APPENDIX G

**ADDITIONAL ANALYSIS AND VALIDATION OF THERMAL-MECHANICAL
EFFECTS ON FRACTURE PERMEABILITY
(RESPONSE TO RDTME 3.20, RDTME 3.21, AND GEN 1.01 (COMMENTS 83 AND 97))**

G.1.1 RDTME 3.20, RDTME 3.21, and GEN 1.01 (Comments 83 and 97)

Figure G-27. Comparison of Stress Versus Aperture Relationship Used in the Distinct Element Analysis and the Recent Continuum Analysis

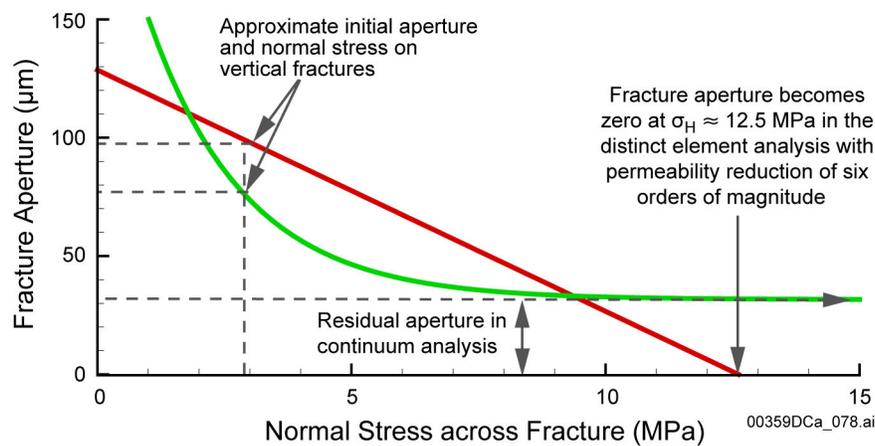
Page 4-86: "The HTOM case predicted a decrease of 6 orders of magnitude in permeability for most vertical fractures during the period from 55 yrs to more than 1,000 yrs after emplacement." It is not obvious how this amount of change would be included in the original distribution of permeability.

As mentioned above, a 6-order-of-magnitude decrease in permeability was estimated for most vertical fractures from 55 years to more than 1,000 years in the distinct element analysis presented in *FY 01 Supplemental Science and Performance Analyses, Volume 1: Scientific Bases and Analyses* (BSC 2001a, Section 4.3.7). In GEN 1.01 (Comment 83), NRC remarked that it is not obvious how this amount of change would be included in the original distribution of permeability. However, as pointed out above, the 6 order-of-magnitude decrease in fracture permeability calculated from the earlier distinct element analysis originally calculated in *Coupled Thermal-Hydrologic-Mechanical Effects on Permeability Analysis and Models Report* (BSC 2001b, Section 6.3.3) is an artifact of an unsubstantiated assumed relationship between normal stress and fracture permeability. The relationship between normal stress and fracture permeability adopted for the distinct element analysis resulted in overstating the fracture permeability because it did not consider residual fracture permeability at high fracture normal stress. It is well known, from numerous laboratory and field experiments, that even if fractures are compressed with a high stress across the fracture planes, the fractures are still open to conduct water flow in voids between fracture surface contacts (Rutqvist and Stephansson 2003, p. 15). According to the most recent analysis documented in *Drift Scale THM Model* (BSC 2004b, Sections 6.5.5, 6.6.2, and 6.7.3), the permeability decreases in vertical fractures within the repository units are limited to a change of within 2 orders of magnitude of their original values. Observations and model validation against the DST show that thermal-mechanical-induced reductions in permeability during heating are limited to within 1 order of magnitude of the original (preheating) values.

Figure G-27 shows a comparison of the relationship between normal stress and aperture used for fractures in the distinct element analysis (BSC 2001b) and the relationship adopted in the most recent continuum analysis (BSC 2004b). It is shown that the linear relationship between normal stress and aperture used in the distinct element analysis of *Coupled Thermal-Hydrologic-Mechanical Effects on Permeability Analysis and Models Report* (BSC 2001b) results in a complete fracture closure and zero permeability at a normal stress of about 12.5 MPa. Such a relationship between normal stress and aperture is unrealistic and cannot be used to reproduce permeability changes observed in the DST. On the other hand, in the continuum analysis (BSC 2004b), a residual aperture is defined into the normal stress versus aperture relationship of fractures that ensures that water flows along fractures even at a high normal stress. The stress versus aperture relationship and the resulting stress versus permeability function used in the continuum analysis have been extensively validated against air-permeability measurements at the DST (BSC 2004b, Section 7).

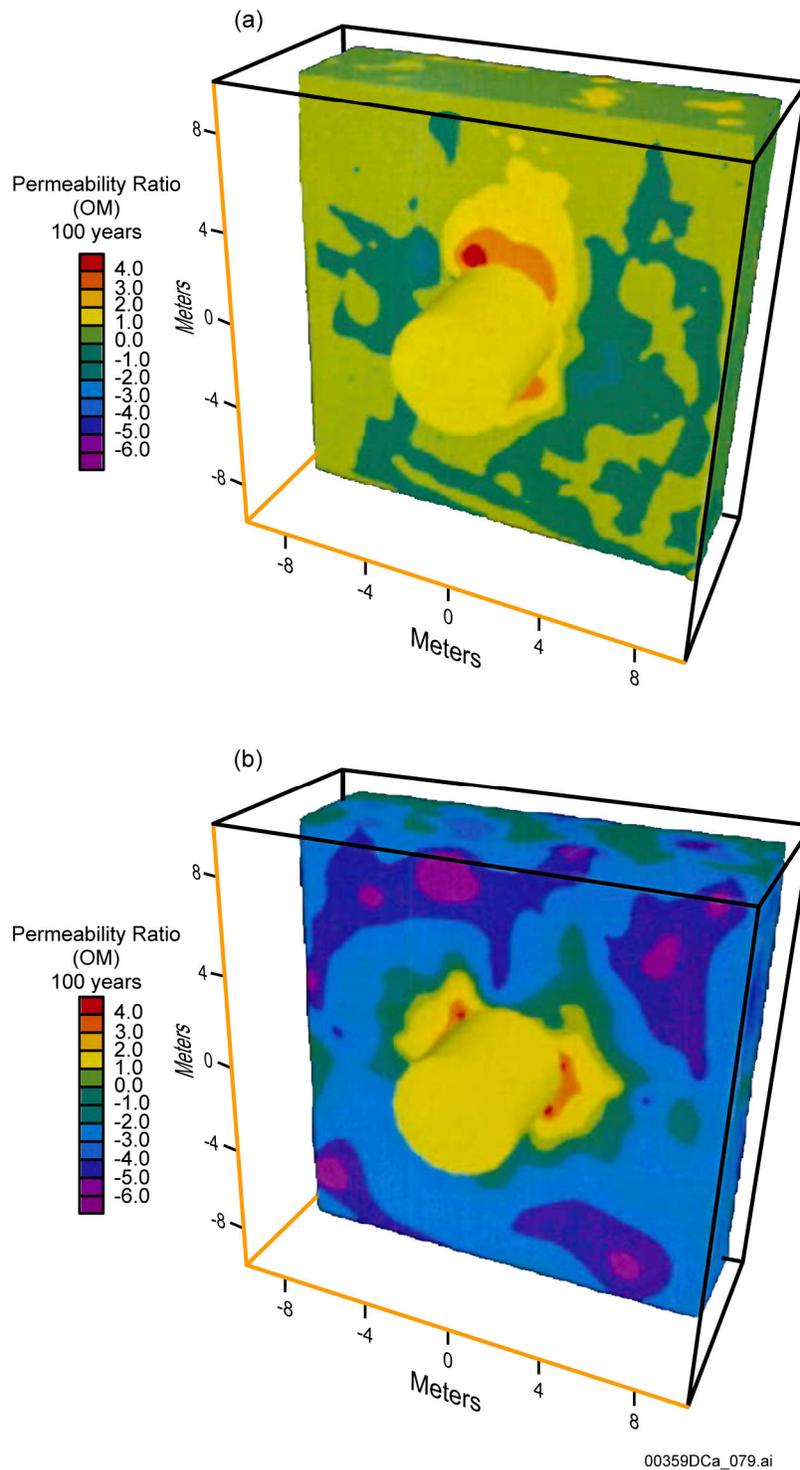
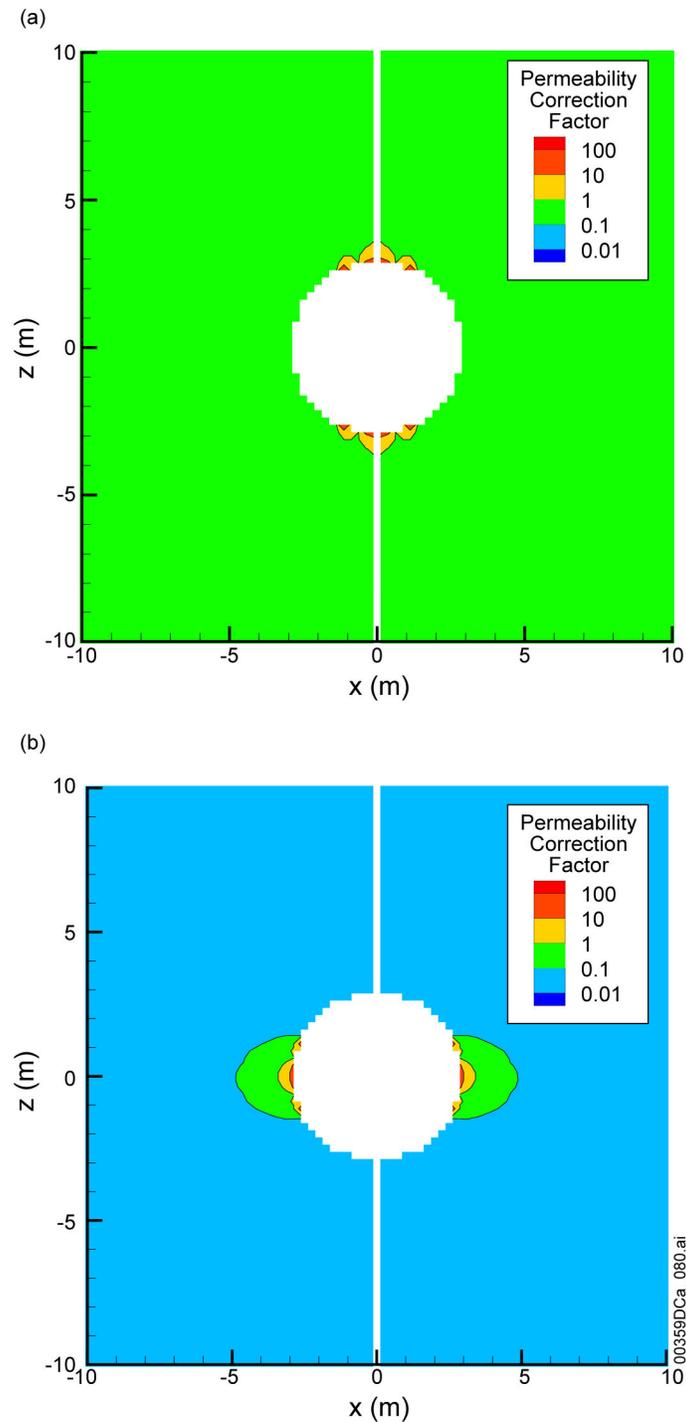
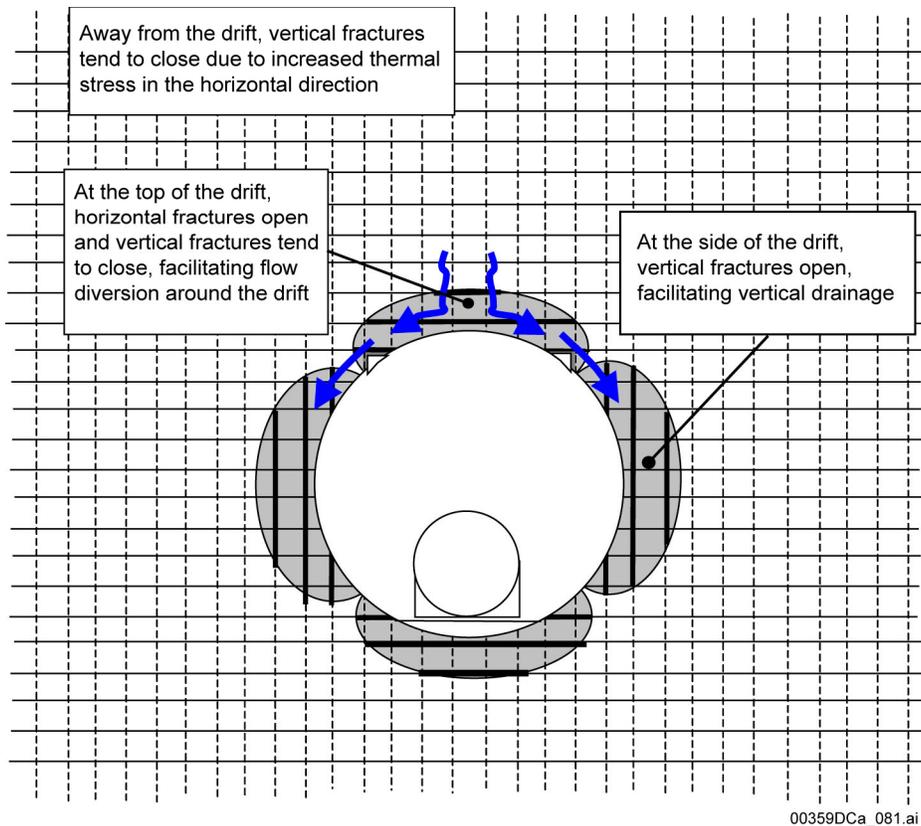
Page 4-97: “There are apparent contradictory results at the drift wall: there is an increase in permeability in the distinct element analysis, but there is a decrease in permeability in the continuum analysis.” This appears to be the area of the problem that one should be most concerned about, due to the influence on seepage.”

As mentioned above, in *FY 01 Supplemental Science and Performance Analyses, Volume 1: Scientific Bases and Analyses* (BSC 2001a) there was an apparent disagreement between results from the distinct element analysis and the continuum analysis regarding predicted permeability changes near the drift wall. In GEN 1.01 (Comment 97), NRC remarked that this appears to be the area of the problem that should cause the most concern, due to its influence on seepage. The apparent disagreement was observed by comparing the permeability ratio at 55 years in the distinct element analysis (BSC 2001a, Figure 4.3.7-1) with the permeability changes at 10 and 1,000 years in the continuum analysis (BSC 2001a, Figures 4.3.7-12 to 4.3.7-15). However, the comparison of these figures is not very clear, because the figures are at different scales and do not show the same parameters. One figure (BSC 2001a, Figure 4.3.7-1) shows an overall mean permeability change, while others (BSC 2001a, Figures 4.3.7-12 to 4.3.7-15) show changes partitioned as permeability in horizontal and vertical fractures. In the most recent revision of *Coupled Thermal-Hydrologic-Mechanical Effects on Permeability Analysis and Models Report* (BSC 2001b), the output results of the distinct element analysis are partitioned into permeability changes in horizontal and vertical fractures. Figures G-28 and G-29 present results of estimated permeability changes in the distinct element analysis and in the recent TOUGH-FLAC continuum analysis (BSC 2004b), respectively. Both figures present changes in permeability of vertical and horizontal fractures at 100 years. These figures show that both analyses consistently predict a reduction in permeability of vertical fractures on top of the drift and an increase in vertical permeability in the sidewall of the drift. Furthermore, both analyses consistently predict an increased permeability of horizontal fractures on the top of the drift and a decreased permeability of horizontal fractures in the sidewall of the drift. As noted in Section G.4.4, the distinct element analysis predicts a larger magnitude of permeability changes as an artifact of an unsubstantiated assumed relationship between normal stress and fracture permeability. The relationship between normal stress and fracture permeability adopted for the distinct element analysis resulted in overstating the fracture permeability because it did not consider residual fracture permeability at high fracture normal stress. However, the basic responses of fracture opening and fracture closure at different locations around the drift wall is consistent between the two analyses. The only exception might be cases in which the distinct element analysis produces large displacements in loose rock block near the drift wall. Such loose blocks were predicted in the distinct element analysis at the sidewall of the drift. This is shown in Figure G-28 as local zones of red contours with an additional increase in permeability.

The comparison of thermal-mechanical-induced permeability changes, with potential influence on seepage, calculated with the distinct element analysis and the continuum analysis is summarized in Figure G-30. For seepage of water into the drift, permeability changes on top of the drift are most relevant. It is clear that both approaches predict a decrease in vertical permeability and an increase in horizontal permeability on top of the drift. Generally, a decrease in vertical permeability and an increase in horizontal permeability indicate that water will be more easily diverted around the drift and, thus, be less likely to enter the drift. The reduced potential for seepage as a result of such thermally induced changes in vertical and horizontal permeability has also been shown in *Seepage Model for PA Including Drift Collapse* (BSC 2003a, Section 6.7).
